License to Operate On-Site Sewage Treatment and Disposal Facility

Permit of Authorization to Construct an On-Site Sewage Facility Permit Valid For One Year From Date Issued

Permit Number:	115778
Issued This Date:	03/06/2023
This permit is hereby given to:	WILLIAM B. & ANGELA M. BEASLEY

1421 CIRCLE ACRES BULVERDE, TX 78163

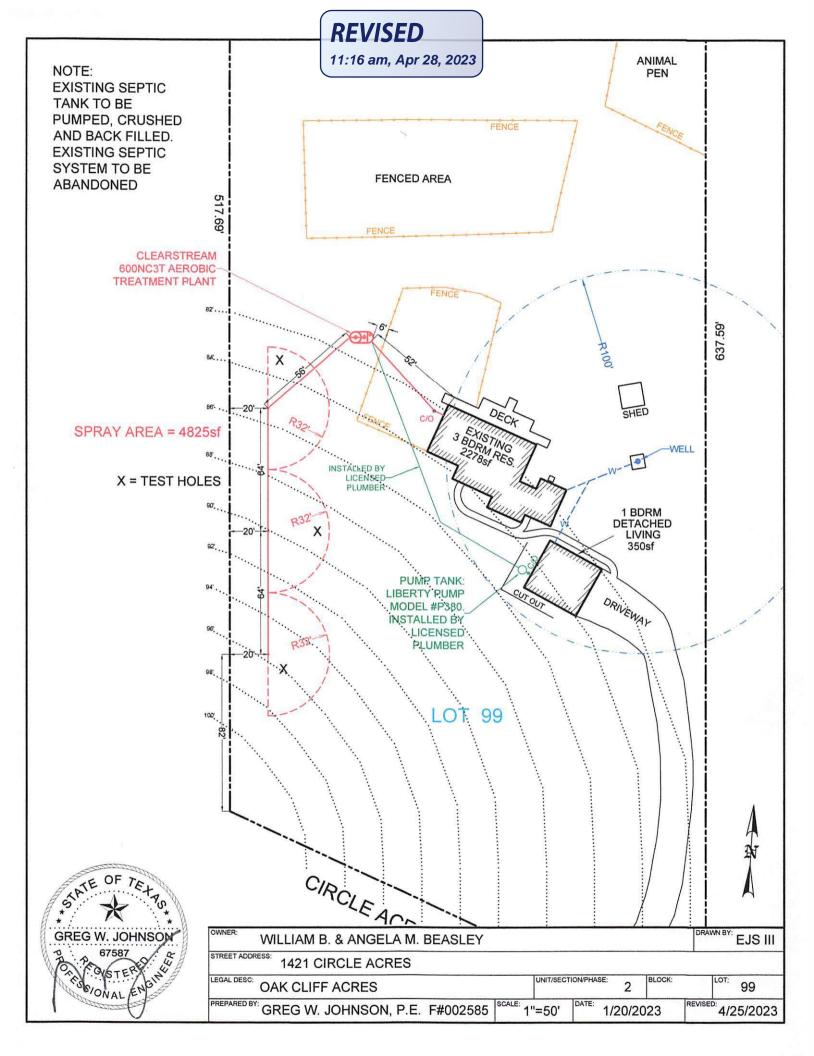
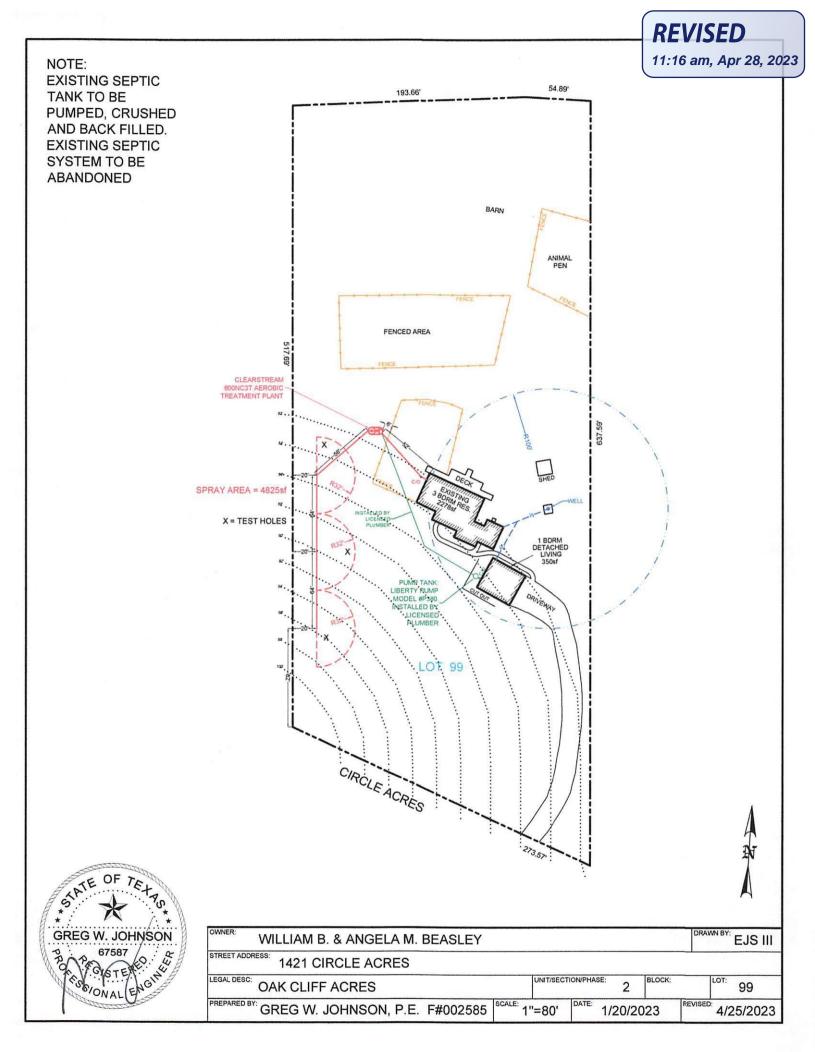
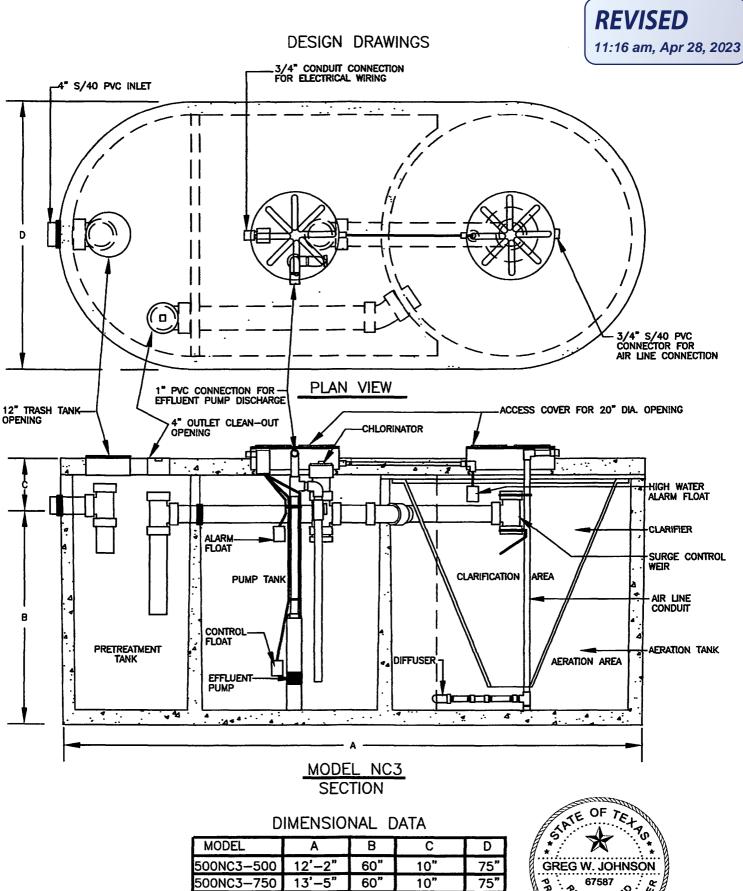
Fre these both going to be used by a single family? There is no Single-Family affidavit in the permit submittal.

- A 3 Bedroom <2500sq. ft has a GPD of 240 and 1 Bedroom <1500sq. ft has a GPD of 180 with a combined total of 420 GPD
- 2. Revise accordingly and resubmit.

OUR DESIGN SHOWS AN EXISTING 3 BDRM RES @ 2278sf AND A 1 BDRM DETACHED LIVING @ 350sf WHICH COMES TO TOTAL OF 2628sf A 4 BDRM RES @ 300 GPD. DO YOU HAVE THE CORRECT DESIGN? THANKS.
